ADDISON 239
UNDERGROUND CONDUIT SYSTEM
 SCALE
 PLAN 1" = 20' PROFILE HORZ. 1" = 20' PROFILE VERT. 1" = 5'
 R. BROUSSARD MGR - ENGR S. GEDDIE AREA MGR - ENGR DAVID NOBLET DIST MGR - ENGR
 DATE ISSUED: _____ DATE CONST. COMP'D: _____ SHEET NO. 1
 E. R. NO. _____ JOB NO. 4673074 DRAWN BY TR INDUSTRIES, INC.
 MAP REF. _____ TAX DIST. DB009

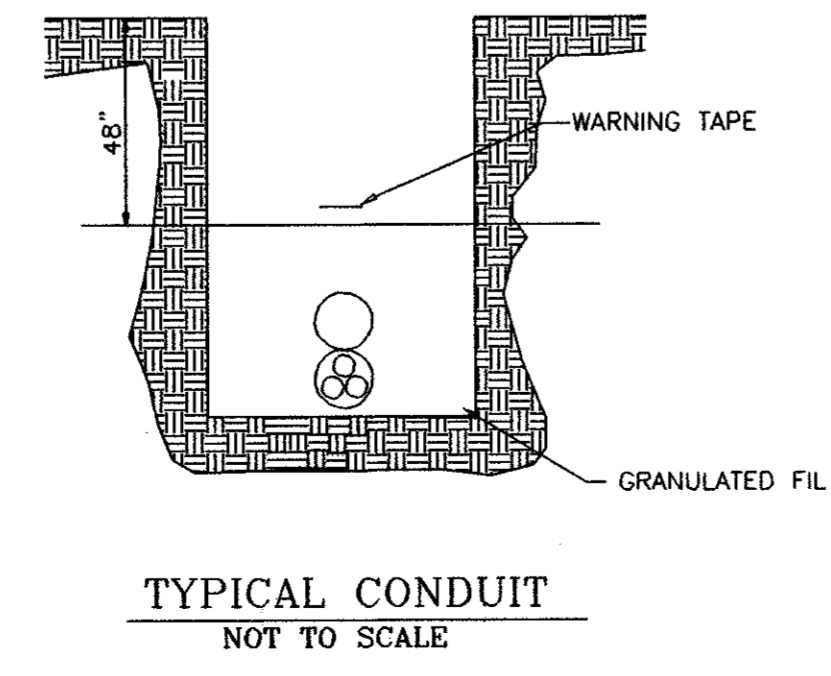
Irrigation lines + electrical lines run under sidewalk also.
